**Champlain Hudson Power Express ("CHPE")
Environmental Management & Construction Plan
Notice of Major Change**

Project: Champlain Hudson Power Express

Segment: 9

Notice Number: 123

PERMIT DRAWING NO. N/A
DRAWING NO. C-114

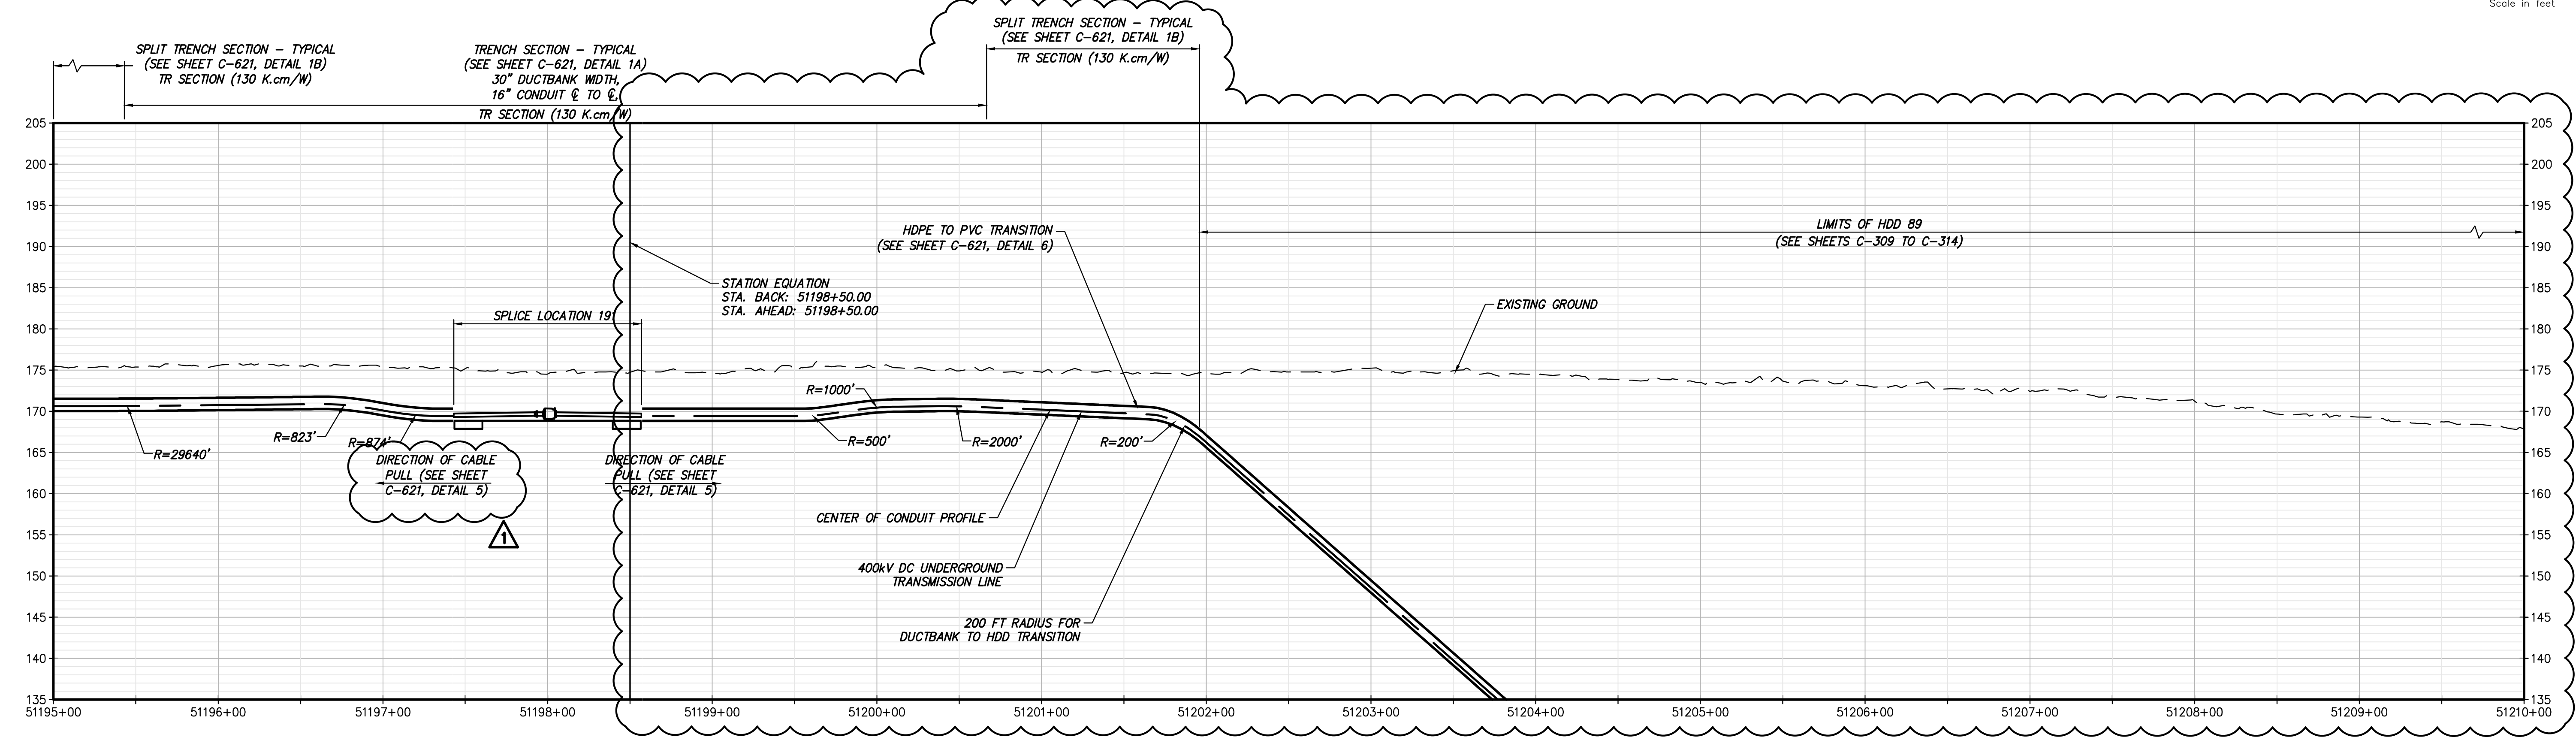
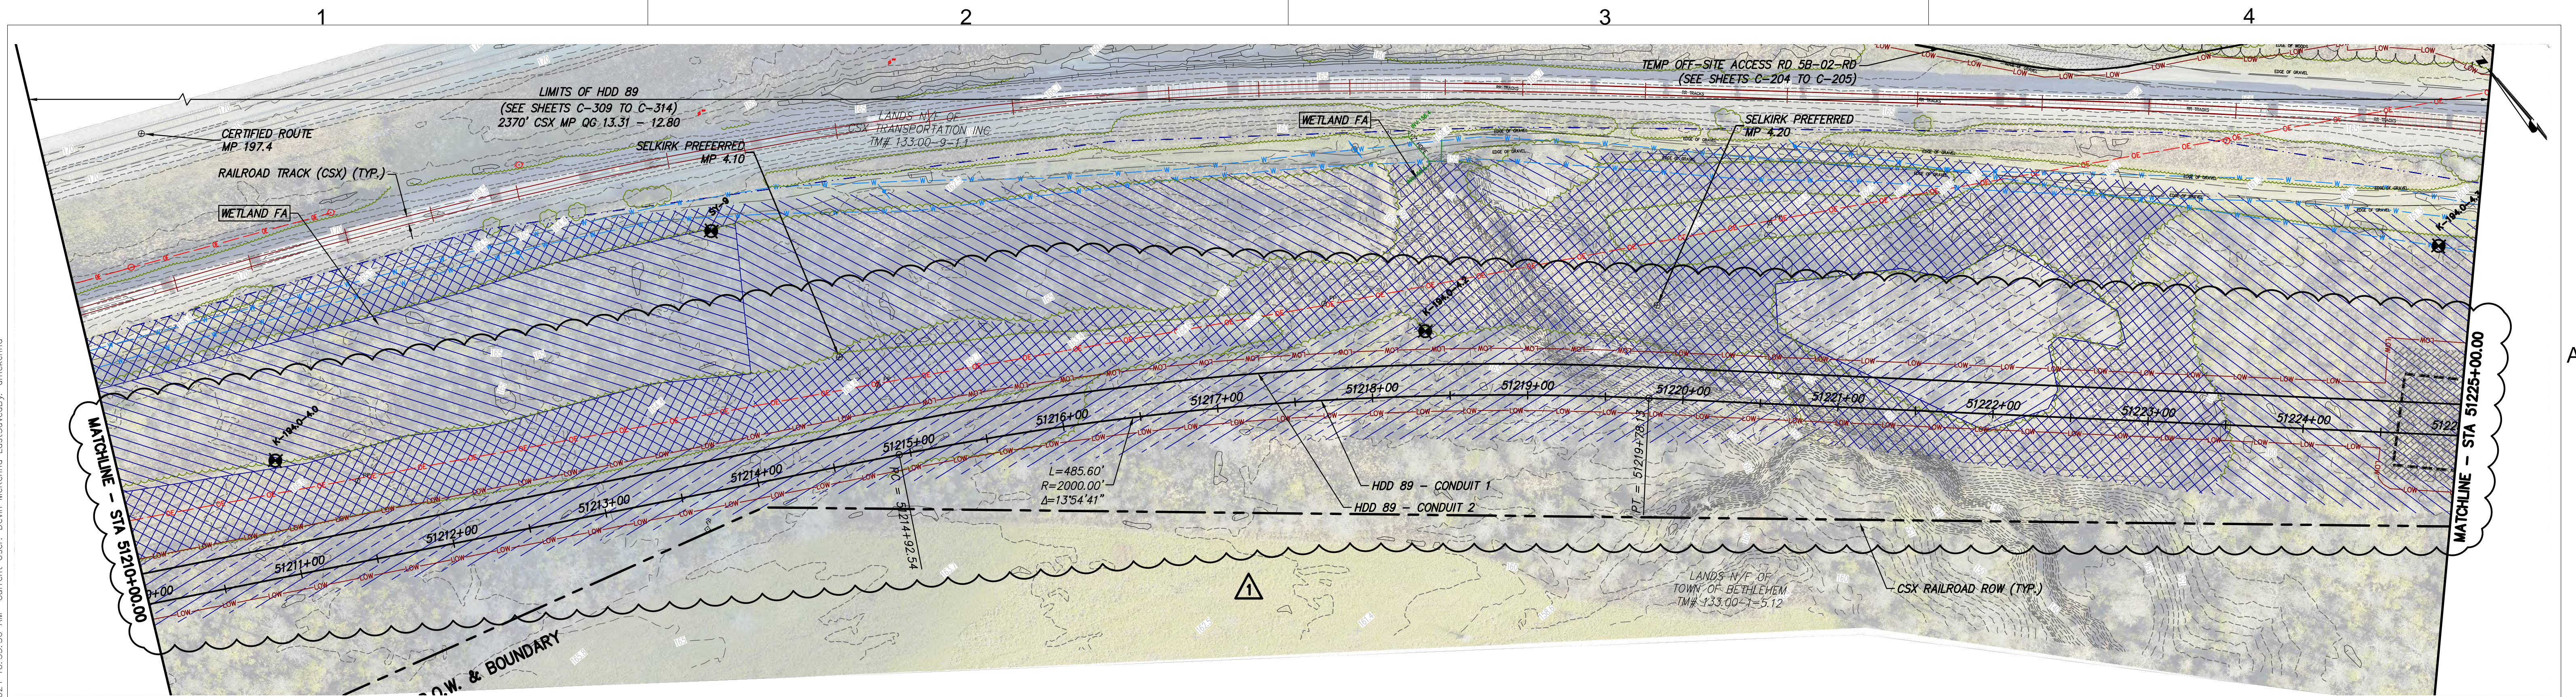
Excursion S9-3 is located within the Town of Bethlehem beginning approximately 0.8 miles north of Bridge Street (Rt. 396) crossing under CSX tracks (approximately STA 51204+00 to 51215+00). See Sheet C-114 and C-115 attached..

Sheet No.	Rev No.	Revision Description	Summary of Plan Changes
C-114	1	NDC-0005_ALIGNMENT REVISIONS PER NAT. GRID COMMENT	Alignment of HDD adjusted to avoid crossing underneath National Grid overhead electric sub-transmission line from STA 51200+00 to STA 51220+00. Extended HDD 89 workspace in front of pits and adjusted LOW and permanent easement accordingly. Corrected wire pull 191 Direction of cable pull to the preferred reverse direction.
C-115	1	NDC-0005_ALIGNMENT REVISIONS PER NAT. GRID COMMENT	Alignment of HDD adjusted to avoid crossing underneath National Grid overhead electric sub-transmission line from STA 51200+00 to STA 51220+00. Extended HDD 89 workspace in front of pits and adjusted LOW accordingly.
C-116	1	NDC-0005_ALIGNMENT REVISIONS PER NAT. GRID COMMENT	Alignment of HDD adjusted to avoid crossing underneath National Grid overhead electric sub-transmission line from STA 51200+00 to STA 51220+00. Extended HDD 89 workspace in front of pits and adjusted LOW accordingly. Corrected wire pull 193 Direction of cable pull to the preferred reverse direction.

No.	DATE	SUBMITTAL / REVISION DESCRIPTION	DB	APP
1	04/19/2024	NDC-0005: ALIGNMENT REVISIONS PER NAT. GRID COMMENT	DM	BD
0	06/09/2023	ISSUED FOR CONSTRUCTION SUBMISSION	BV	TK

PERMIT DRAWING NO.
DRAWING NO.
C-309

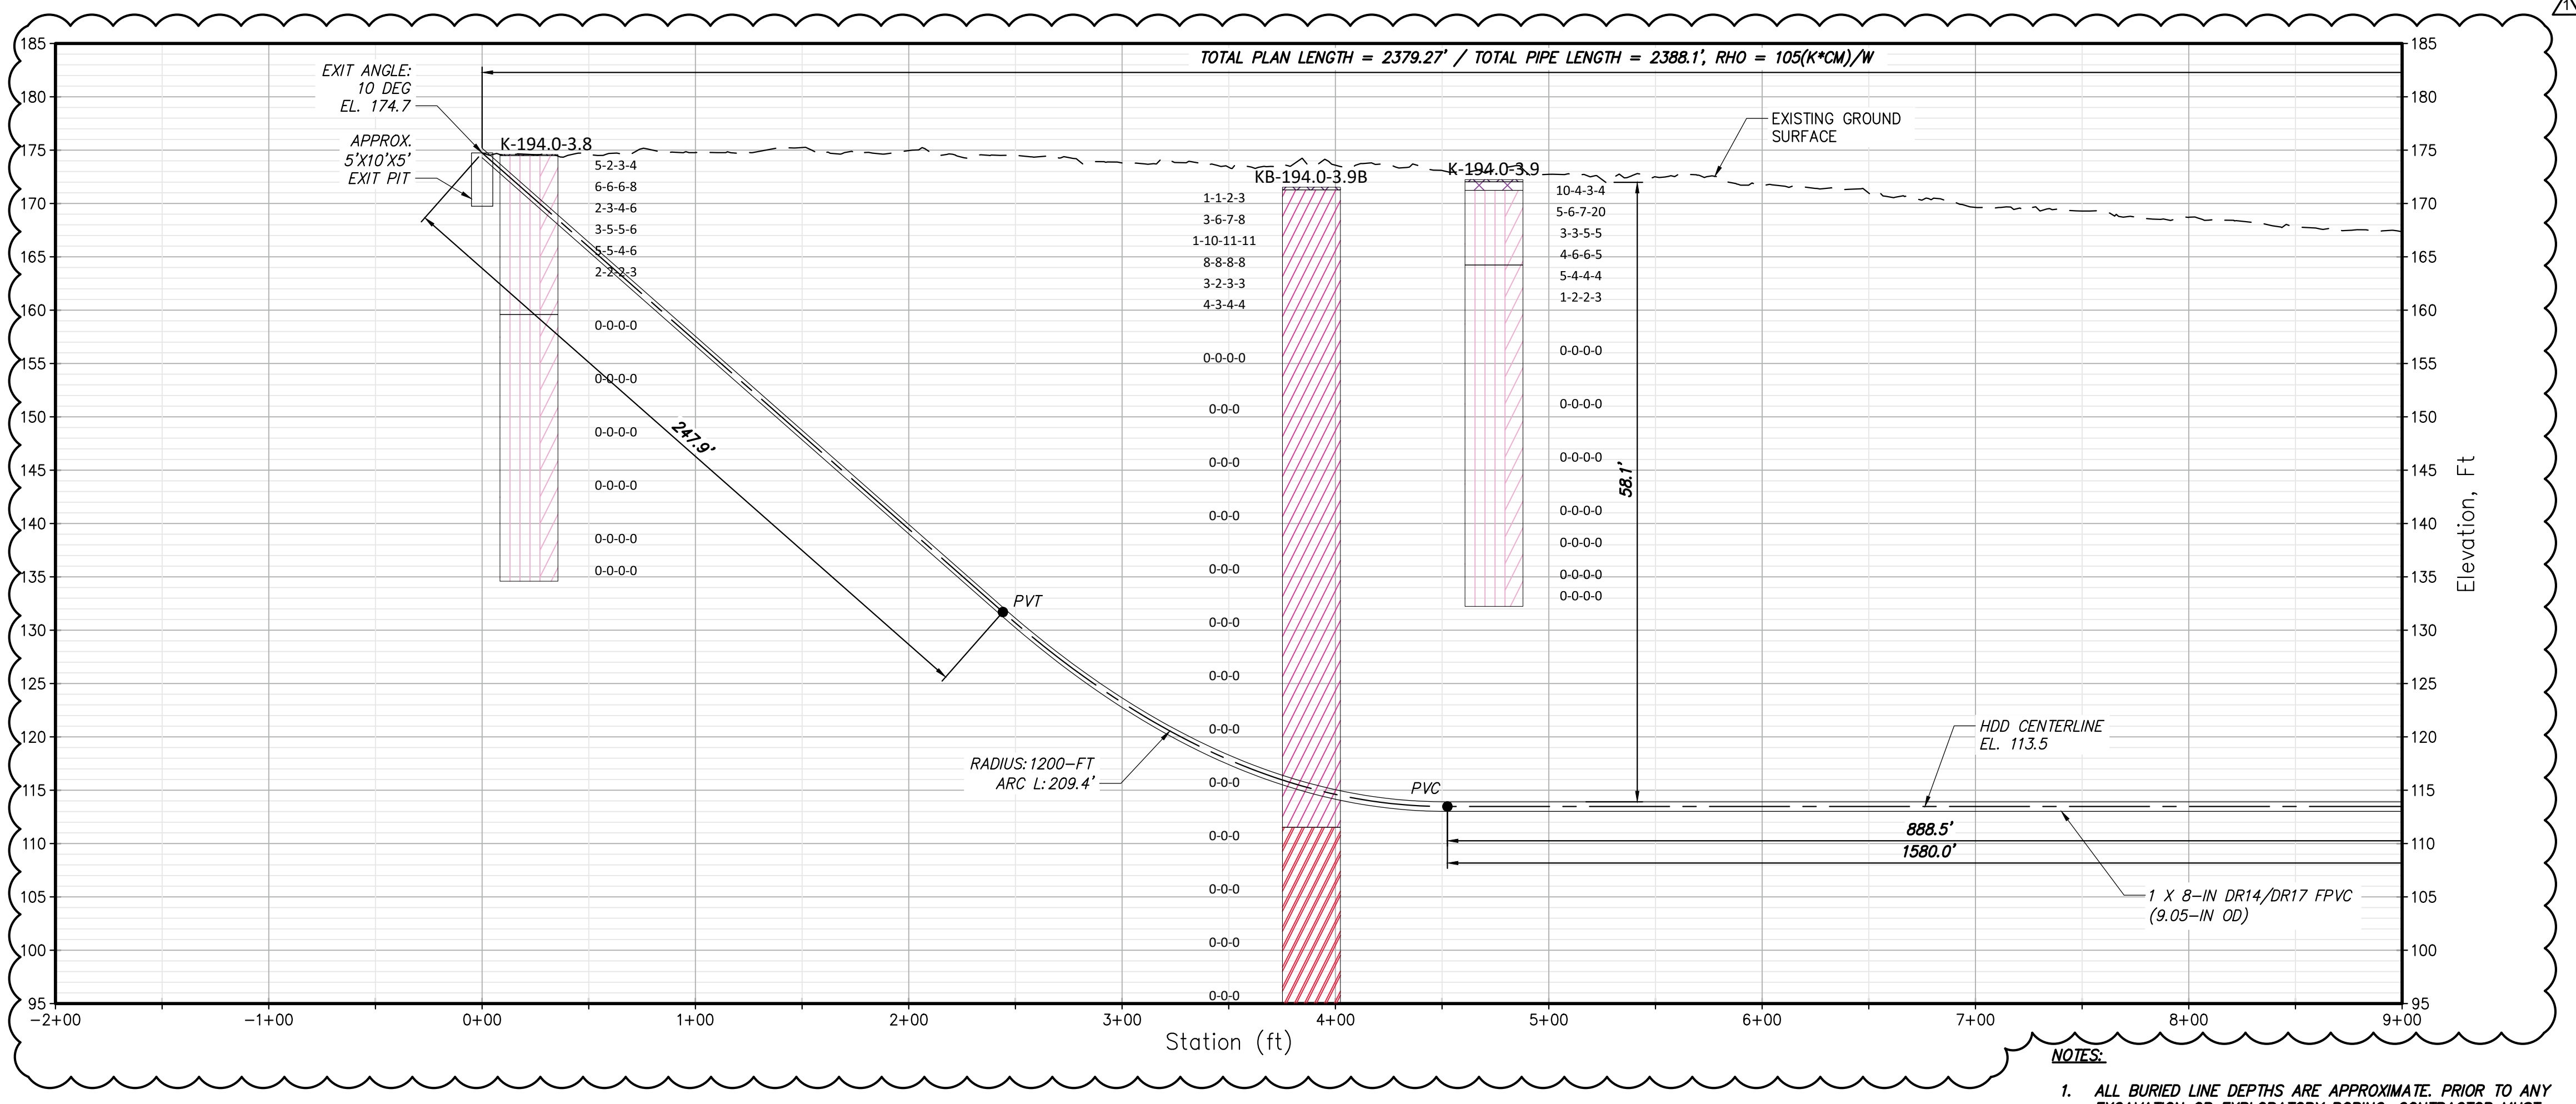
C-309	1	NDC-0005_ALIGNMENT REVISIONS PER NAT. GRID COMMENT	Alignment of HDD adjusted to avoid crossing underneath National Grid overhead electric sub-transmission line from STA 51200+00 to STA 51220+00. Revised HDD Conduit Material Type and Size. Corrected fiber conduit callouts to denote bundling of fiber with Conduit 2.
C-310	1	NDC-0005_ALIGNMENT REVISIONS PER NAT. GRID COMMENT	Alignment of HDD adjusted to avoid crossing underneath National Grid overhead electric sub-transmission line from STA 51200+00 to STA 51220+00. Revised HDD Conduit Material Type and size. Corrected fiber conduit callouts to denote bundling of fiber with Conduit 2.
C-311	1	NDC-0005_ALIGNMENT REVISIONS PER NAT. GRID COMMENT	Alignment of HDD adjusted to avoid crossing underneath National Grid overhead electric sub-transmission line from STA 51200+00 to STA 51220+00. Revised HDD Conduit Material Type and size. Corrected fiber conduit callouts to denote bundling of fiber with Conduit 2.

No.	DATE	SUBMITTAL / REVISION DESCRIPTION	DB	APP
1	04/19/2024	NDC-0005_ALIGNMENT REVISIONS PER NAT. GRID COMMENT	NS	BD
0	06/09/2023	ISSUED FOR CONSTRUCTION SUBMISSION	NS	BD
